UNITED STATES PATENT AND TRADEMARK OFFICE

Office Action Summary	Application No. 10/830,120	Applicant(s) LEE ET AL.	
	Examiner Jarrett J. Stark	Art Unit 2823

DETAILED ACTION

Fig. 2

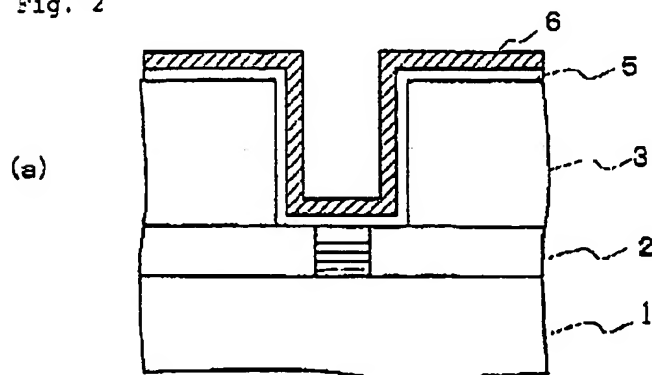
As claim 1 is currently written, the broad claim language does not distinctly exclude the disclosed stack type capacitor structure as shown in Figure 3 of Aoki et al. As shown below layer 6 is a metal layer lower electrode having a cylindrical shape that defines a cylindrical space. Layer 8 is a second metal layer that completely fills in the space defined by the first metal layer.

Fig. 2

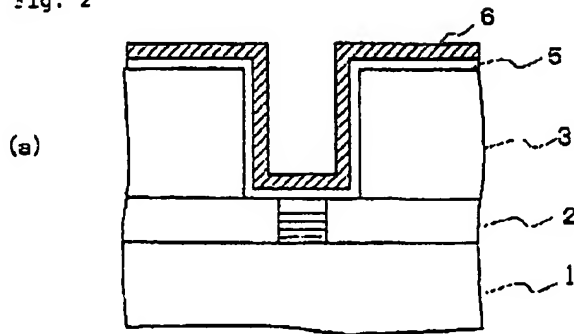
a lower electrode; (Aoki et al., Fig. 2 ref #'s 5&6)

a dielectric layer formed on the lower electrode; (Aoki et al., Fig. 2 ref # 7)

a first metal layer having a cylindrical shape and defining a cylindrical space; and (Aoki et al., Fig. 2 ref # 6)

a lower electrode; (Aoki et al, Fig. 2 ref #'s 5&6)

a dielectric layer formed on the lower electrode; (Aoki et al, Fig. 2 ref # 7)

(Aoki et al, Fig. 2 ref # 6)

Fig. 3

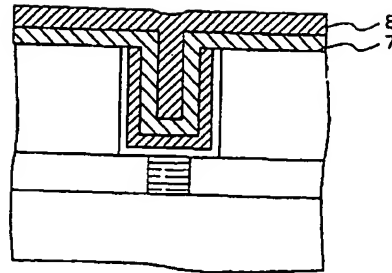
and an upper electrode formed on the dielectric layer, (Aoki et al., Fig. 3 ref # 8)

a second metal layer completely filling the cylindrical space defined by the first metal layer (Aoki et al., Fig. 3 ref # 8)

and an upper electrode formed on the dielectric layer, (Aoki et al, Fig. 3 ref # 8)

a second metal layer completely filling the cylindrical space defined by the first metal layer (Aoki et al, Fig. 3 ref # 8)
